# Certificate of Appropriateness

3014 W. MC KINLEY BL., Cold Spring Park Historic District  
W.J. Sherrard, Owner

Rebuild front porch deck, railings and guardrails and skirting.

PTS ID 73258 COA, rebuild front porch deck and railings

Detail of tops for main porch posts

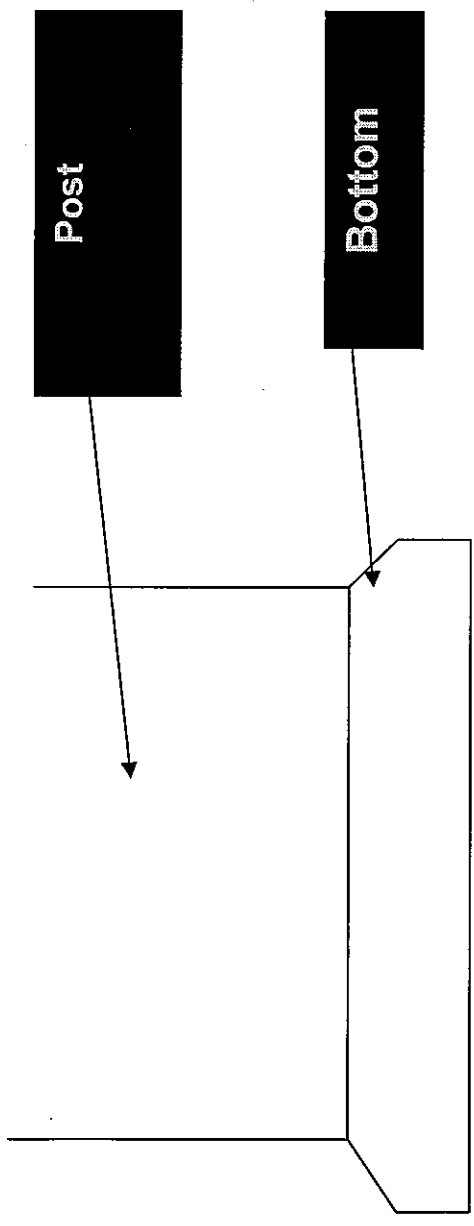
All work must be done according to attached drawings and photos. All wood must be painted upon completion. Please note that research has shown that when new, bare wood is left exposed to the elements for a period of only a week or two, the life of the paint job applied over it will be decreased. Newel posts at bottom of stairs will be 5-1/2" square and built according to the attached drawings. Porch flooring will be center-match. The four main porch posts will be box-style and 6" square. All work must be done in a craftsman-like manner, and must be completed within one year of the date this certificate was issued. Staff must approve any changes or additions to this certificate before work begins. Work that is not completed in accordance with this certificate may be subject to correction orders or citations. If you require technical assistance, please contact Paul Jakubovich of the Historic Preservation staff as follows: Phone: (414) 286-5712 Fax: (414) 286-3004 E-mail: [pjakub@milwaukee.gov](mailto:pjakub@milwaukee.gov). If permits are required, you are responsible for obtaining them from the Milwaukee Development Center. If you have questions about permit requirements, please consult the Development Center's web site, [www.mkedcd.org/build](http://www.mkedcd.org/build), or call (414) 286-8210.

Detail of post bottom, 1-1/2" thick

**Porch floor must be made of center-match material**

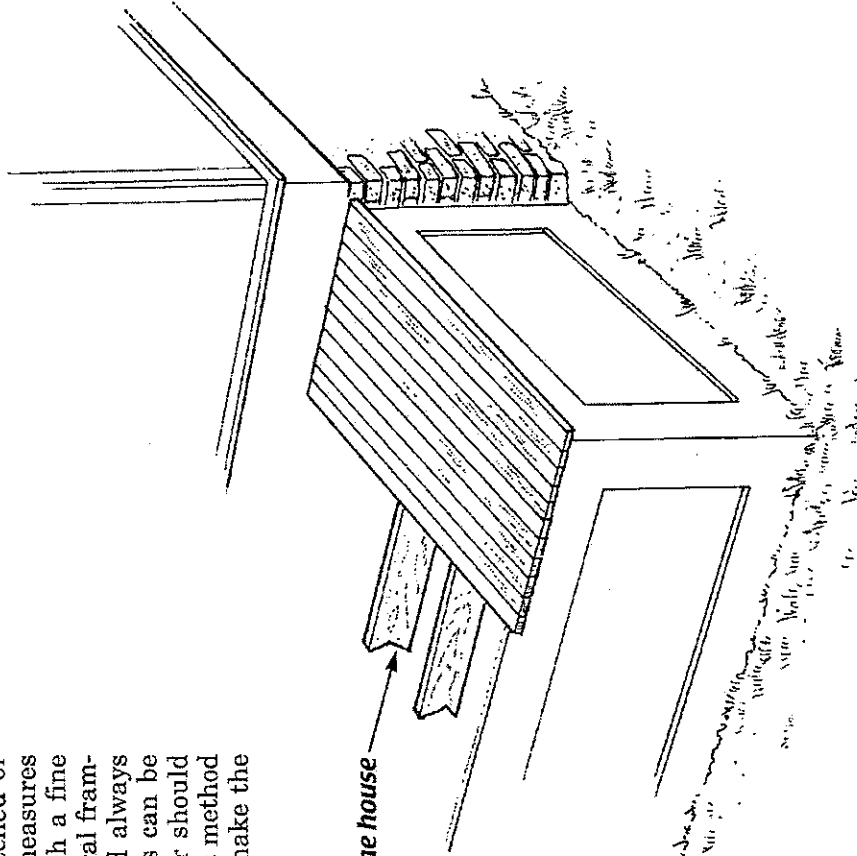
Porch floors should be constructed of center matched or tongue-and-groove wooden flooring, which typically measures 2-1/4" wide by 3/4" thick. This flooring gives the porch a fine finished appearance. The joists, which are the structural framing members to which the flooring is attached, should always be run parallel to the house so that the floor boards can be installed perpendicular to the house. The porch floor should also be very slightly pitched away from the house. This method of construction for a porch floor will shed water and make the porch last longer.

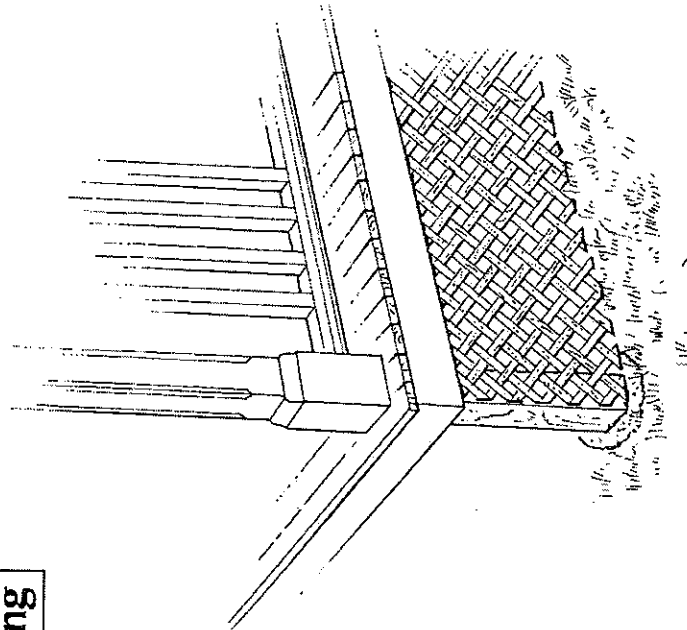
Skirting, such as this lattice panel, enclosed the area beneath the porch floor. It should always be installed with a continuous board frame around it that is wide enough to cover the rough framing lumber that supports the porch deck.

Do not install a lattice skirting without a frame around it. The rough framing lumber that supports the porch will show through and the raw edges of the lattice look unfinished.

**Detail of handrail and guardrails, please see detail drawing  
of post tops.**

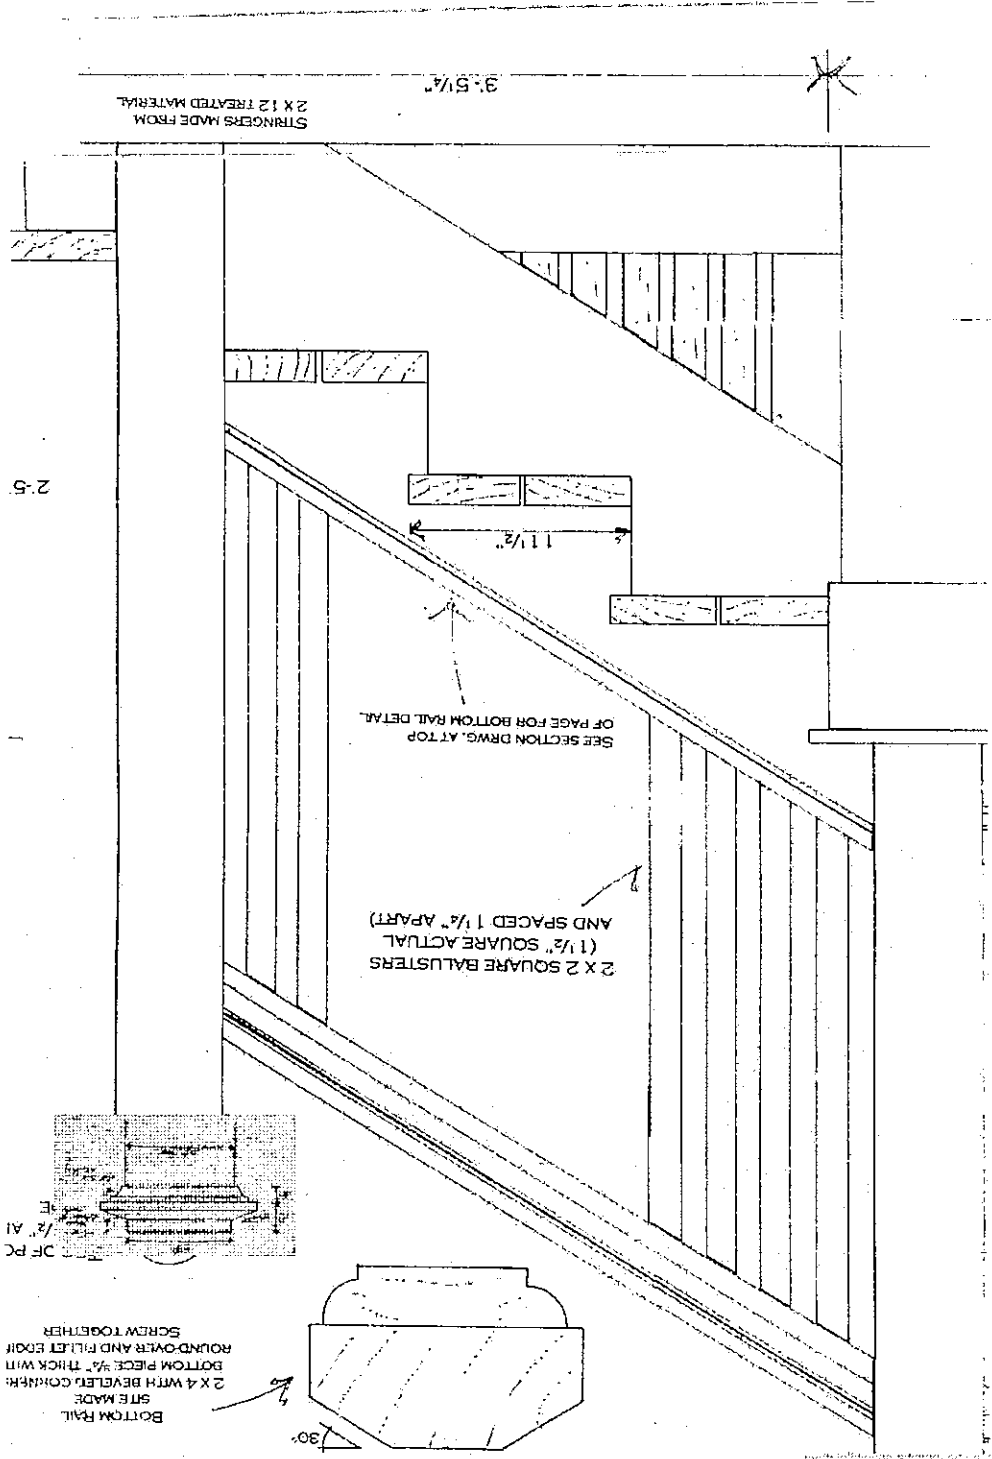
As an alternate to the lattice work infill, pickets 2" wide actual and spaced 3/4" apart (must be attached to back of skirting frame

SEE SECTION DRWG. AT TOP  
OF PAGE FOR BOTTOM RAIL DETAIL

2 X 2 SQUARE BALUSTERS  
(1 1/2" SQUARE ACTUAL  
AND SPACED 1 1/2" APART)

BOTTOM RAIL  
SITE MADE  
2 X 4 WITH BEVELED CORNER  
BOTTOM PIECE 3/4" THICK WITH  
ROUND-OVER AND FLIT EDGE  
SCREW TOGETHER
